SERVICE BULLETIN REVISION TRANSMITTAL SHEET

TITLE : AIR CONDITION - PACK TEMPERATURE CONTROL - INSTALL IMPROVED PACK
TEMPERATURE-CONTROLLERS (7HH AND 27HH)

MODIFICATION No. : 23987K3521

This page transmits Revision No 01 of Service Bulletin No A320-21-1106.

NB6 21 1106 AAMA-A

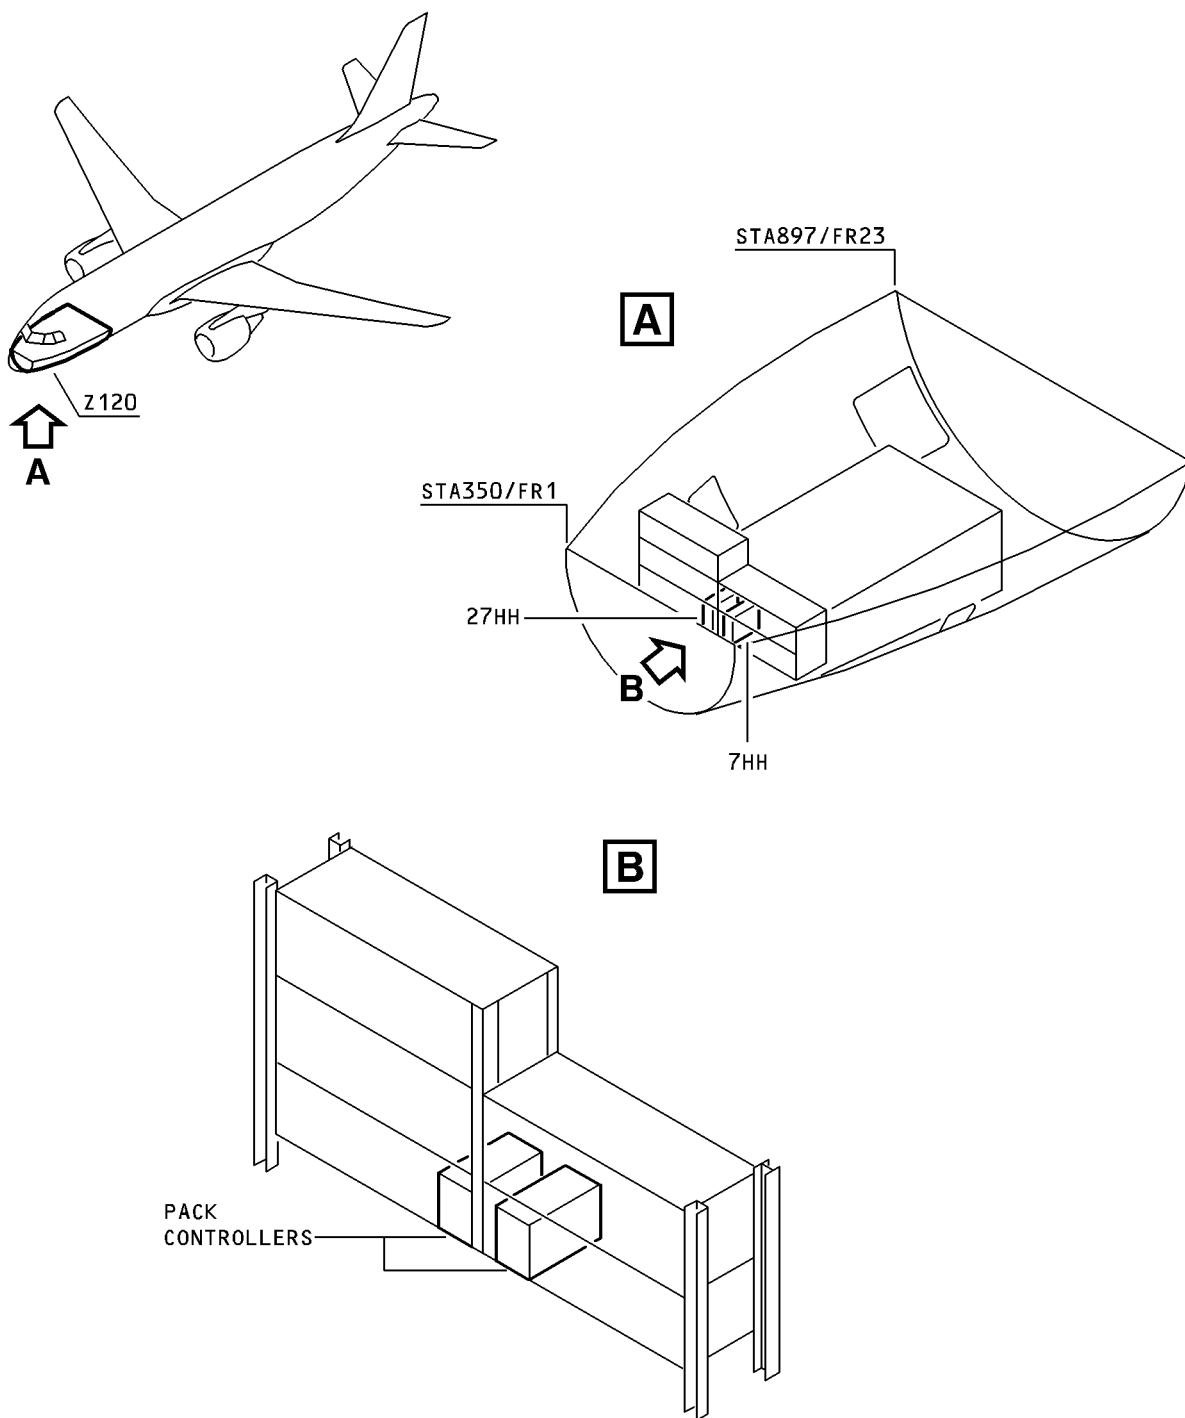
With the accomplishment of this Service Bulletin, the pack temperature-controllers 759A0000-10 will be replaced by the pack temperature-controllers 759C0000-02 which has the automatic anti-icing cycle deleted and therefore needs to be installed in conjunction with the AIV -08.

NOTE : Interchangeability code 03, two way interchangeable only on A320, if the air conditioning pack has the latest standard anti-ice valve 748A0000-08 (refer to Service Bulletin A320-21-1065). Installation of P/N 759A0000-10 on A319 and A321 is not approved.
